# UNITED STATES PATENT AND TRADEMARK OFFICE

10/728,324

<b>Office Action Summary</b>	<b>Application No.</b> 10/728,324	<b>Applicant(s)</b> MALLIK ET AL.	
	<b>Examiner</b> Leonardo Andújar	<b>Art Unit</b> 2826

## DETAILED ACTION

**Fig. 3**

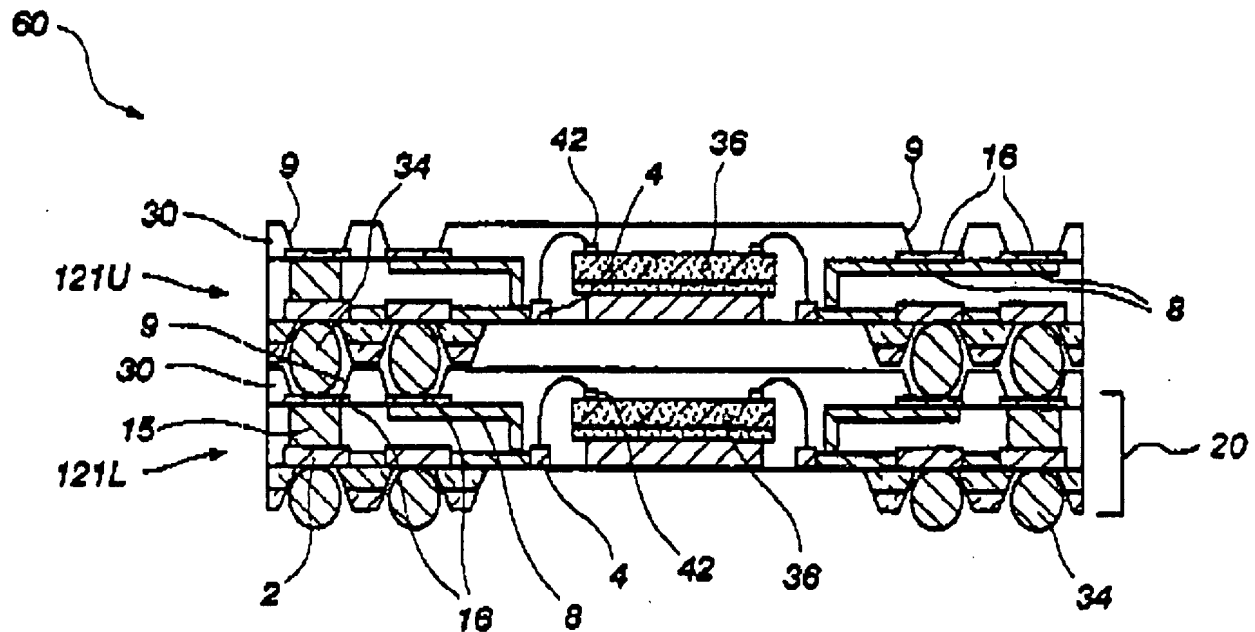
Taniguchi does not show that the second interconnect is in contact with the first interconnect within the opening also that the first interconnect is a solder ball. However, Lee (e.g. fig. 3) shows an interconnect having a first interconnect 15/16 and a second interconnect 34 wherein the second interconnect is in contact with the first interconnect within the opening whereas Somaki (e.g. fig. 6) teaches a first and a second interconnect (13 a, b) wherein the first and second interconnects are solder balls. According to Somaki this embodiment allows higher shear strain tolerances, greater reliability and higher conductivity (col. 3/lls. 30-40).

It would have been obvious to one of ordinary skill in the art at the time the invention was made connect the second interconnect the first interconnect disclosed by Taniguchi within the opening to make a package having a reduced thickness as taught by Lee (see col. 3/lis. 17-40) and to use a solder balls as first interconnect and second interconnects as suggested by Somaki to allow for higher shear strain tolerances, greater reliability and higher conductivity.
